TENNESSEE VALLEY AUTHORITY  
BROWNS FERRY NUCLEAR PLANT (BFN)  
UNITS 1, 2 AND 3

PROPOSED TECHNICAL SPECIFICATION (TS) CHANGE TS-356  
DESCRIPTION AND EVALUATION OF THE PROPOSED CHANGE

PROPOSED TECHNICAL SPECIFICATION (TS) CHANGE TS-356  
MARKED PAGES

## 4.7.A.2.g (Cont'd)

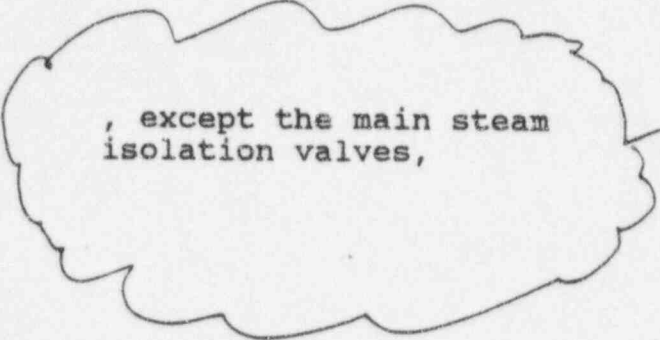
, except the main steam  
isolation valves,

The total leakage from all penetrations and isolation valves shall not exceed 60 percent of  $L_a$  per 24 hours. Leakage from containment isolation valves that terminate below suppression pool water level may be excluded from the total leakage provided a sufficient fluid inventory is available to ensure the sealing function for at least 30 days at a pressure of 54.6 psig. Leakage from containment isolation valves that are in closed-loop atomic class I lines that will be water sealed during a DBA will be measured but will be excluded when computing the total leakage.

##### 4.7.A.2. (Cont'd)

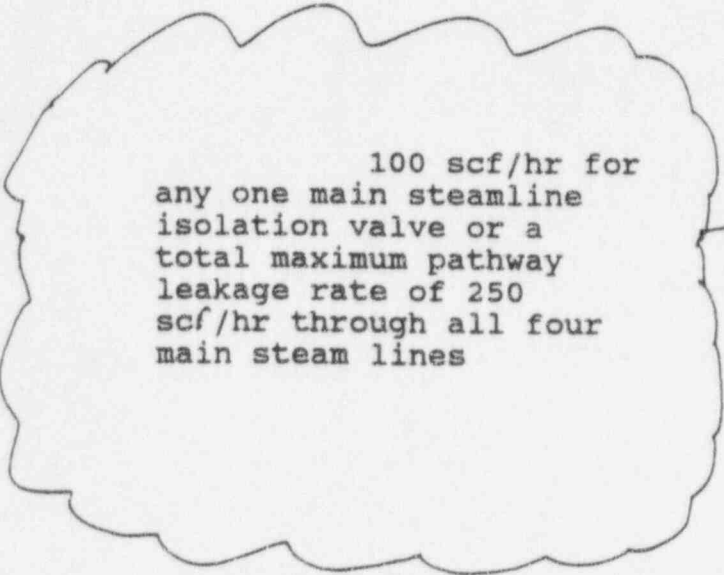
i. The main steamline isolation valves shall be tested at a pressure of 25 psig for leakage during each refueling outage. If the leakage rate of ~~11.5 scf/hr for any one main steamline isolation valve~~ is exceeded, repairs and retest shall be performed to correct the condition.

100 scf/hr for  
any one main steamline  
isolation valve or a  
total maximum pathway  
leakage rate of 250  
scf/hr through all four  
main steam lines
